Rickman Property: Preliminary Plan No. 120170020

Staff Report Date: 6/15/18

Rickman Property, Preliminary Plan No. 120170020:

Recommendation: Approval with conditions

Figure 3 – Preliminary Plan No. 120170020

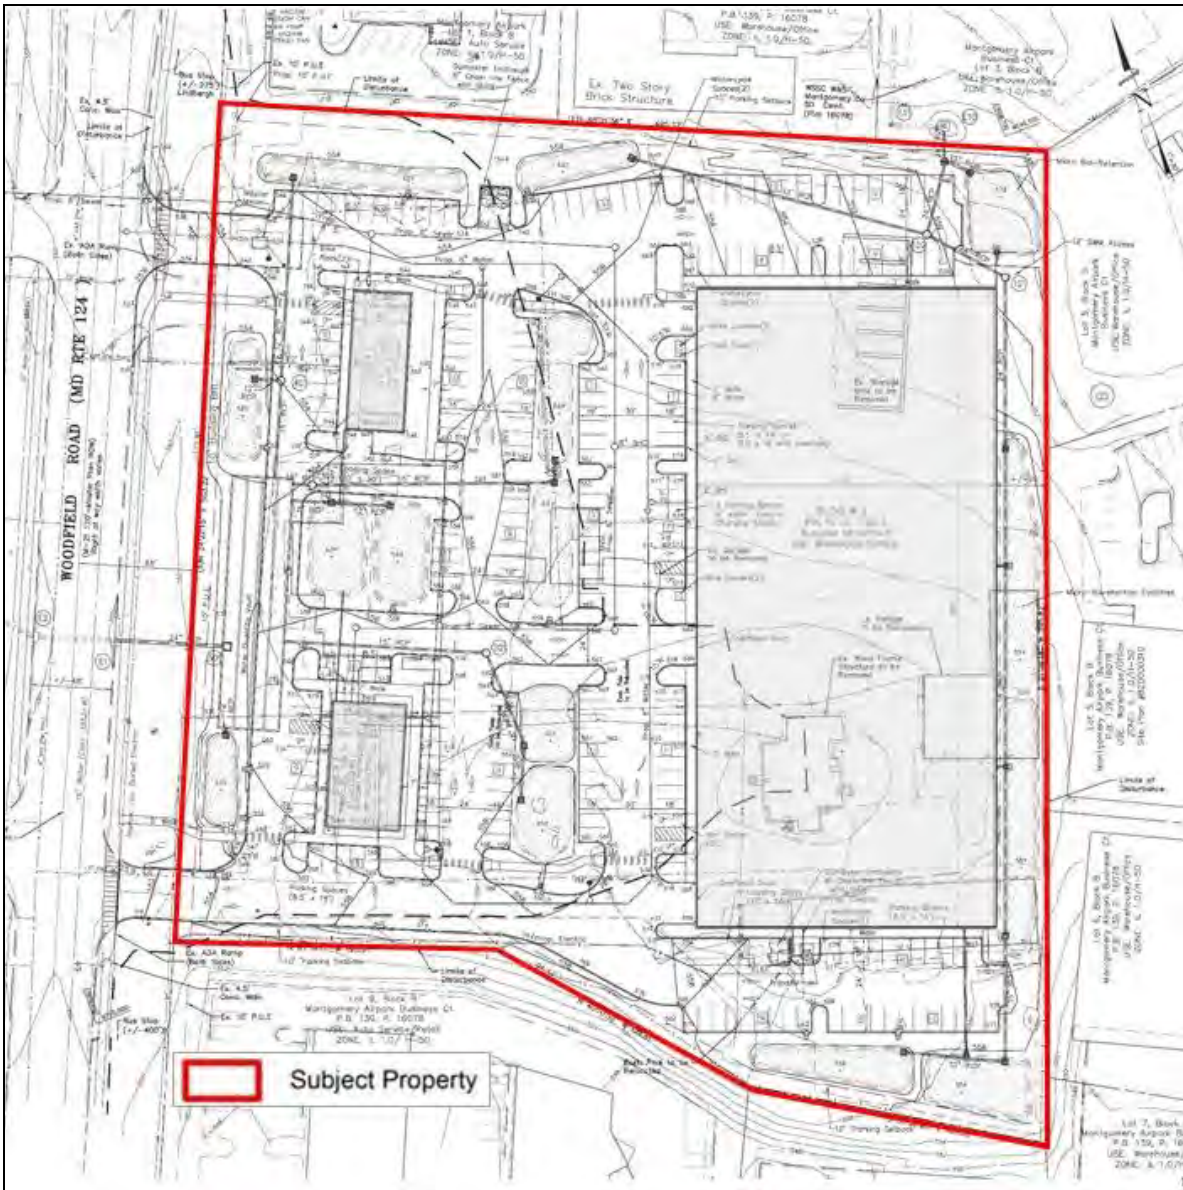
We have completed our review of the revised preliminary plan uploaded to eplans on February 20, 2018. A previous plan was reviewed by the Development Review Committee at its meeting on January 24, 2017. We recommend approval of the plan subject to the following comments:

1. Submit storm drain study and site plan prior to submission of the record plat. Analyze the capacity of the existing downstream public storm drain system and the impact of the post-development ten (10) year storm runoff on same. If the proposed subdivision drains to an existing closed section street, include spread computations in the impact analysis.
2. Provide a ten (10) foot wide Public Utility Easement (PUE) along all existing street frontages.

3. Relocation of utilities along existing roads to accommodate the required roadway improvements shall be the responsibility of the applicant.
4. Access and improvements along Woodfield Road (MD 124) as required by the Maryland State Highway Administration.

Figure 5 – Variance Trees and Site Constraints

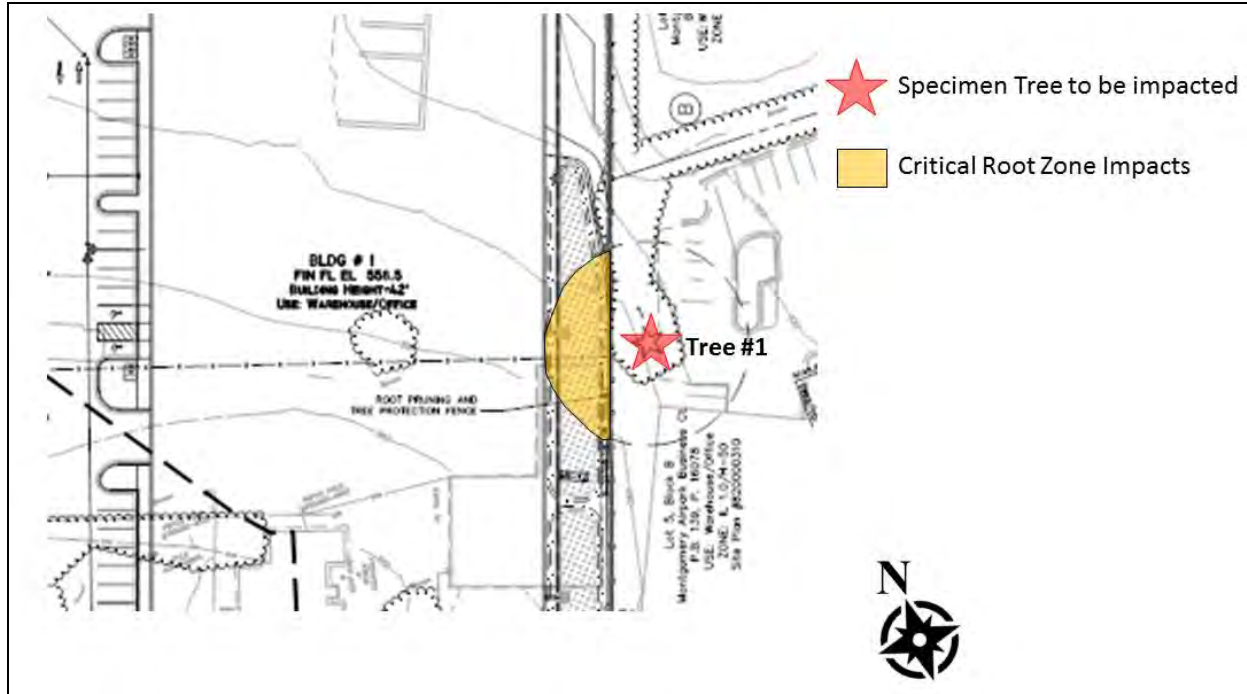
The Applicant submitted a variance request in a letter dated June 15, 2016 (Attachment 5). There is one (1) specimen sized tree located approximately 20-feet off the eastern property line on the neighboring property (Figure 5). The Applicant proposes to impact about 27% of the tree’s CRZ.

Per Section 22A-21(a), an applicant may request a variance from Chapter 22A if the Applicant can demonstrate that enforcement of Chapter 22A would result in an unwarranted hardship. In this case, the Applicant is faced with having to impact 1 off-site specimen tree. Staff has determined that the impacts to this tree for the construction on the Subject Property are unavoidable. The site layout, the required location of the proposed Building #1 and the locations of the necessary storm water management elements have rendered impacts to this tree unavoidable.

The Subject Property is partially located within the Upper Rock Creek Special Protection Area with approximately the eastern half of the site located within this SPA. In early design and layout discussions between the Applicant, M-NCPPC Staff and MCDPS Staff the topic of moving Building #1 closer to MD 124 and out of the SPA was brought up. MCDPS decided that in this case, it is a much better option to locate the proposed building in the SPA and treat the water runoff for the roof with micro-bioretenion structures than to treat water runoff from a large area of surface asphalt parking. It was felt that the

roof run-off would be less likely to carry petroleum chemical contaminants into the SPA than the run-off from the parking lots. For this reason, the proposed Building #1 was relocated to the back of the lot at the eastern Property line and thereby necessitating impacting Tree #1.

Staff recommends approval of the variance request.

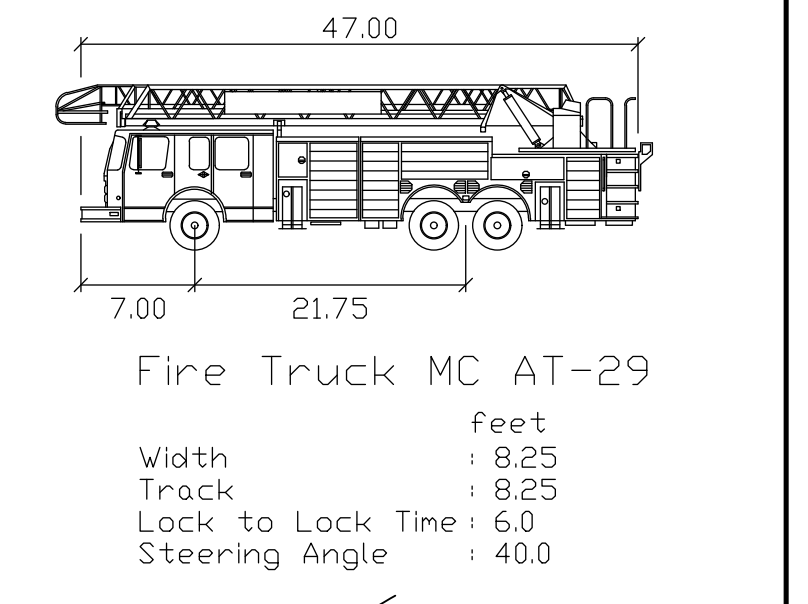
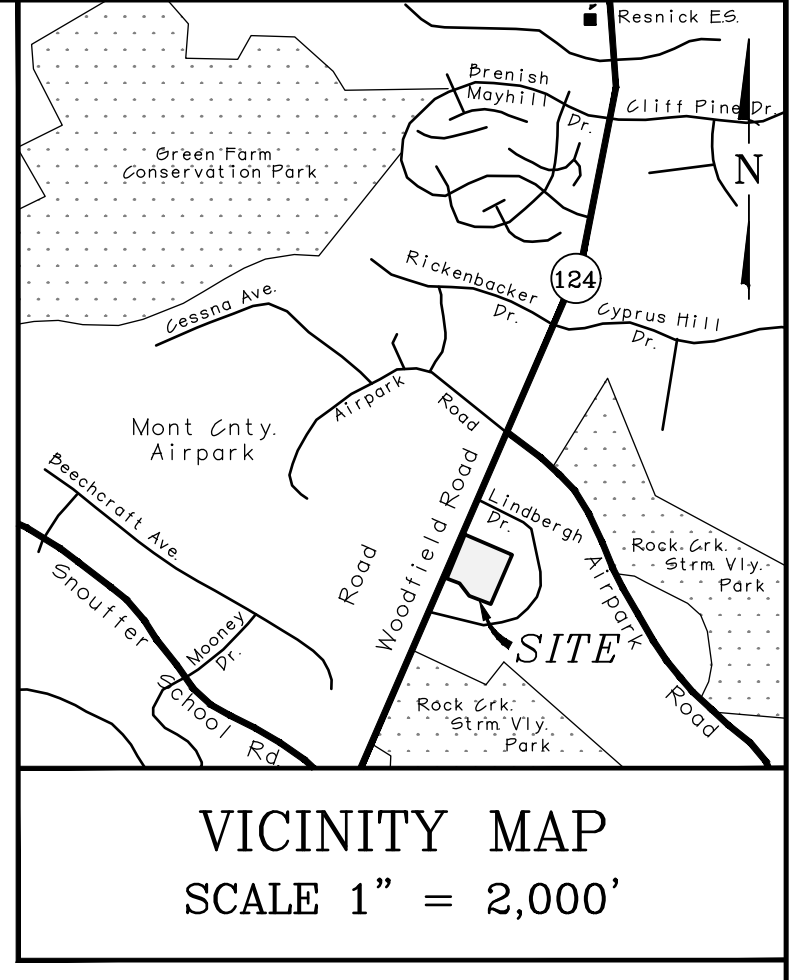
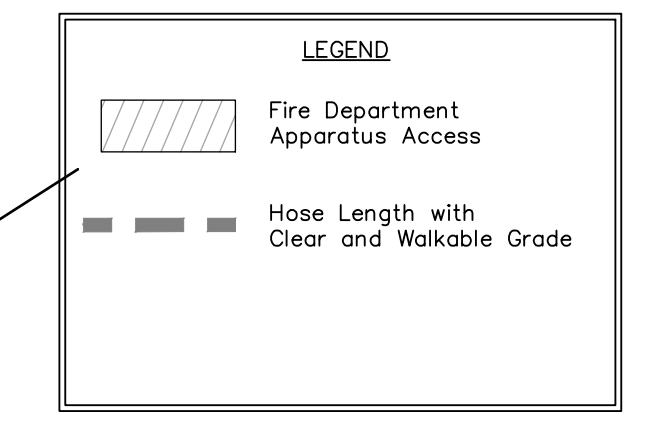
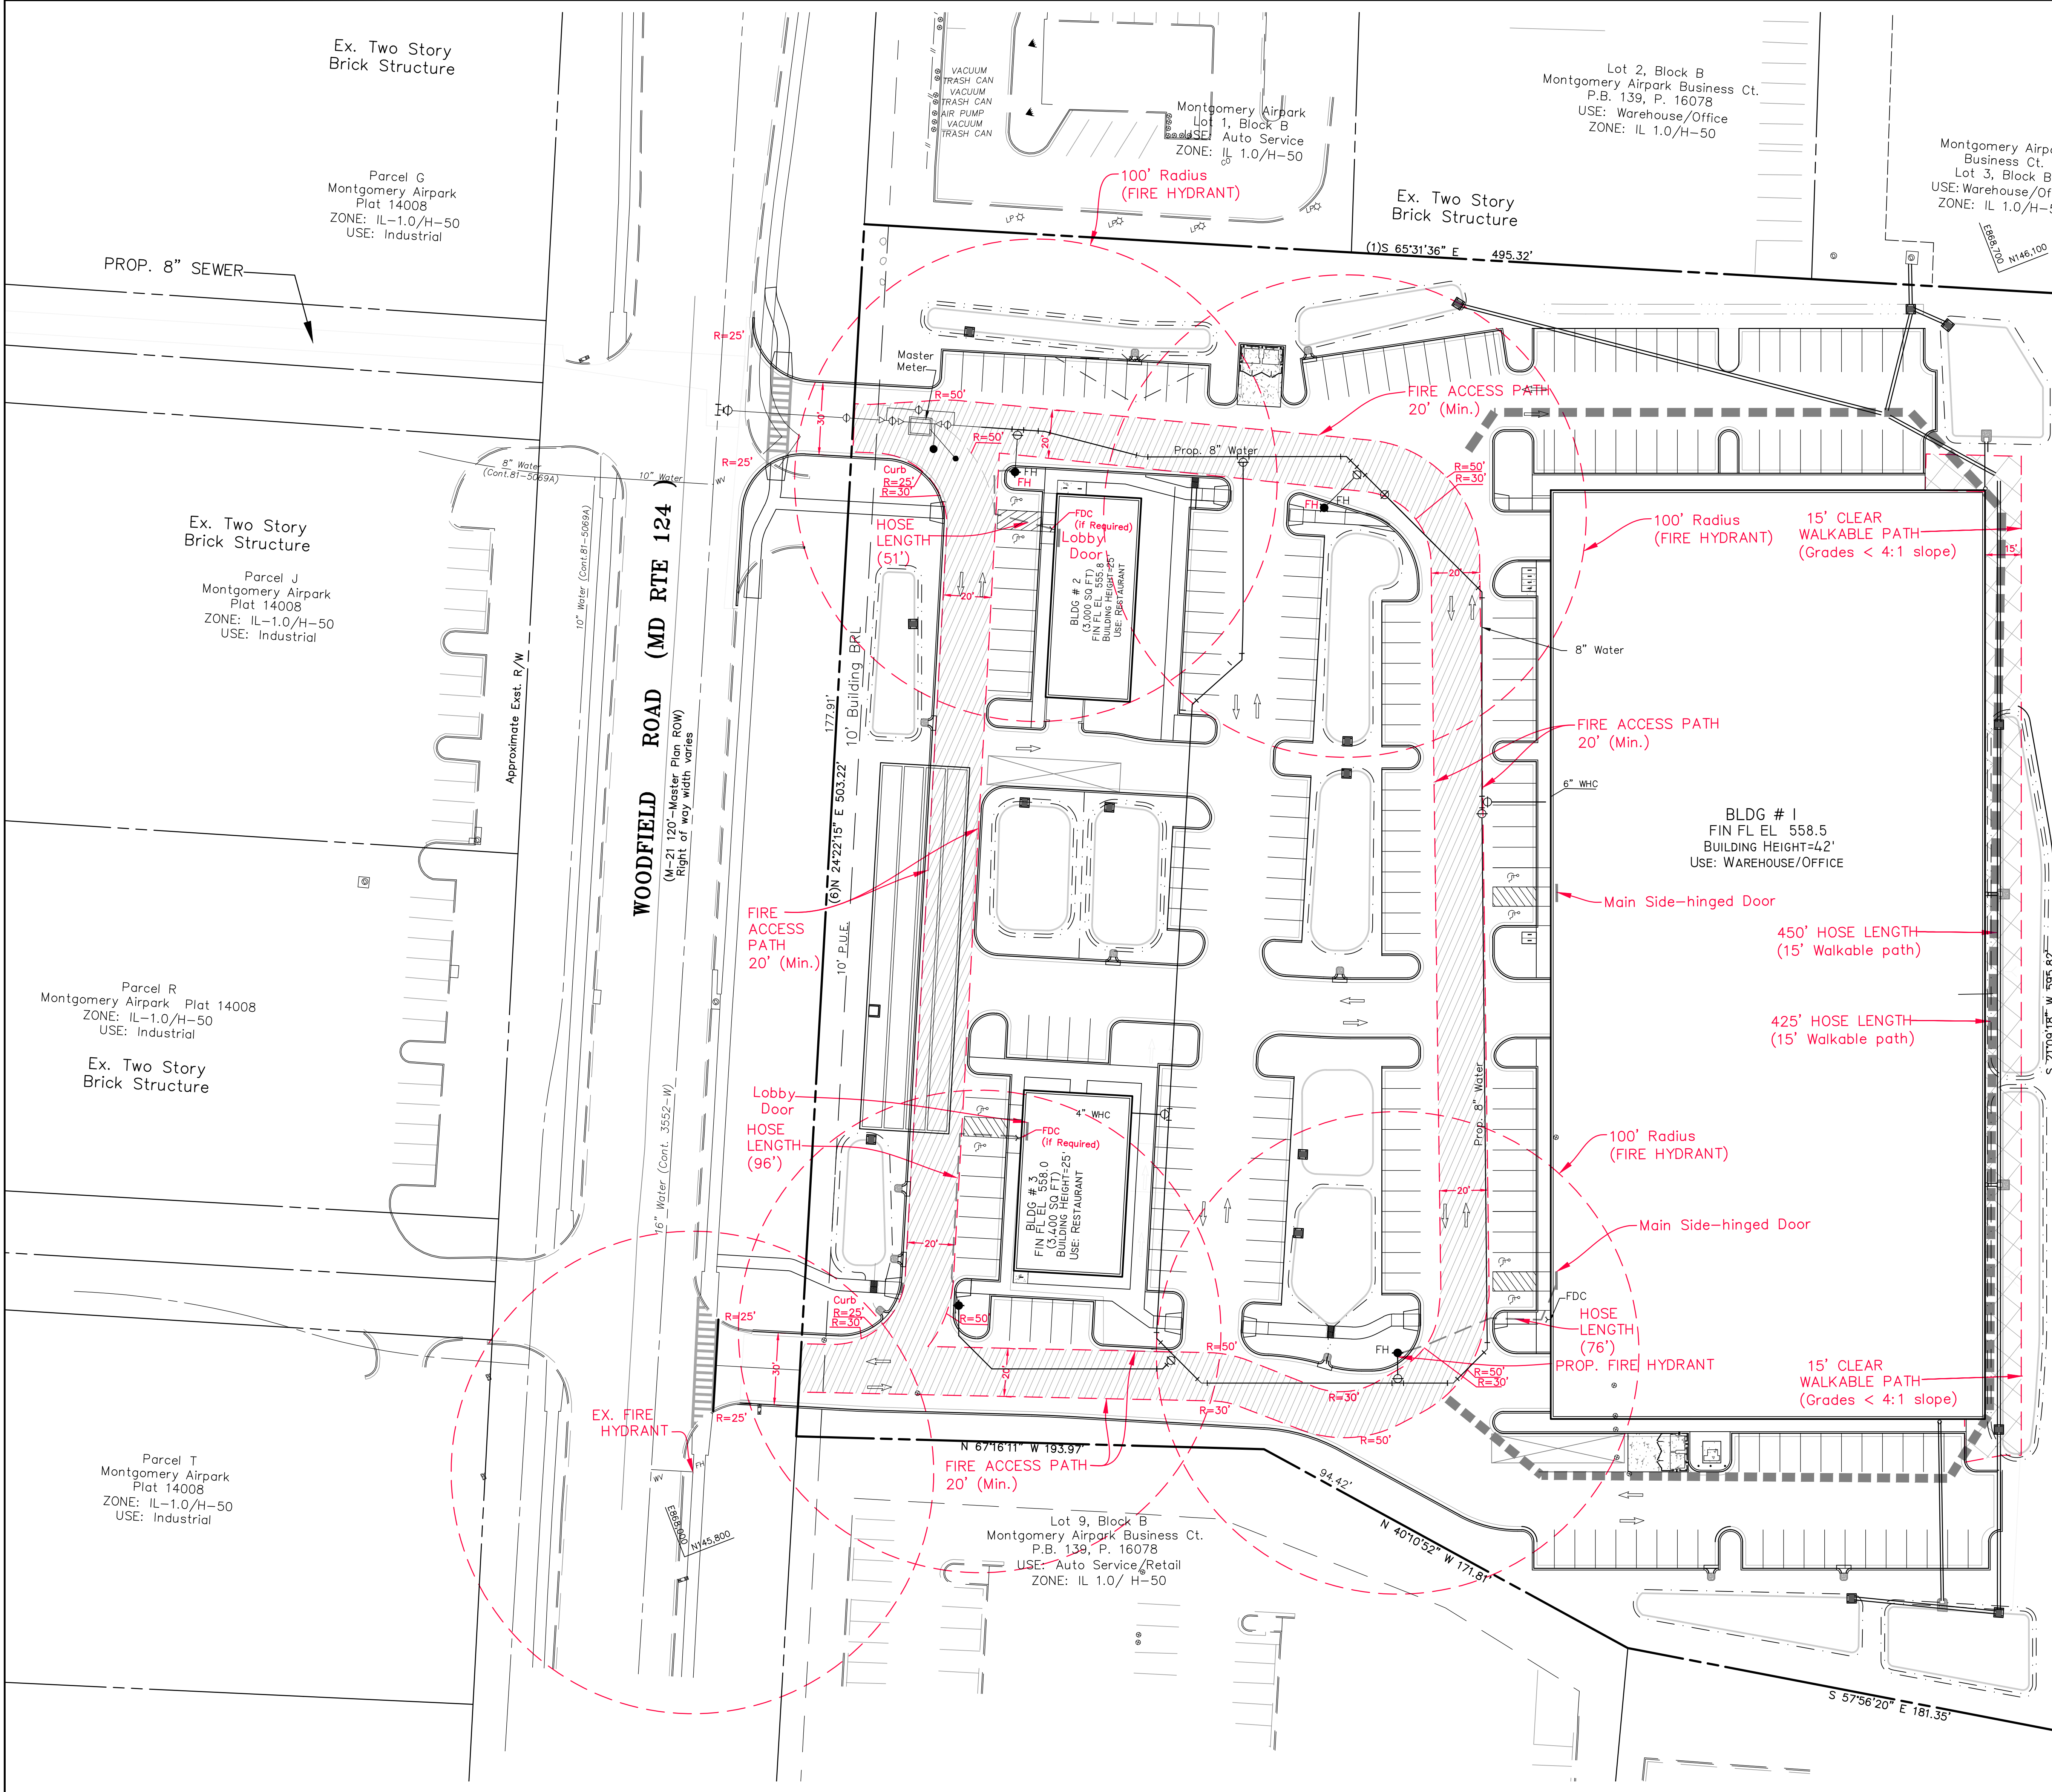
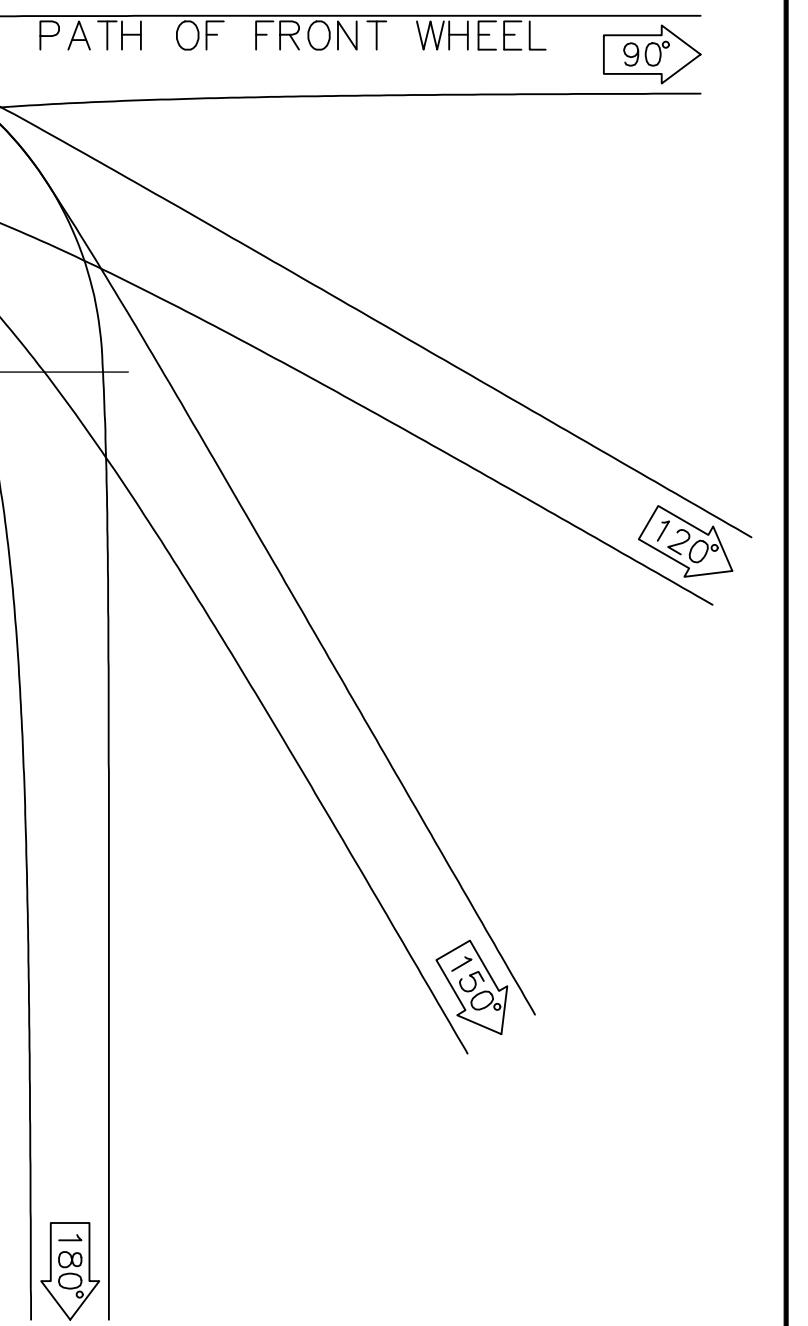
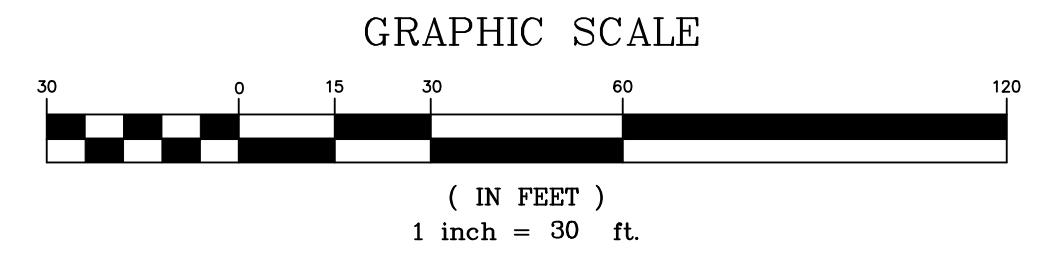
The fire department access and water supply plan (attached) received by email on June 12, 2018 is acceptable.

This plan assumes that buildings 2 and 3 will not require automatic fire suppression systems. In the event that Buildings 2 or 3 require an automatic fire suppression system; the access, fire hydrant location, and placement of a fire department connection shall be in accordance with the current Fire Safety Code- Building Construction.
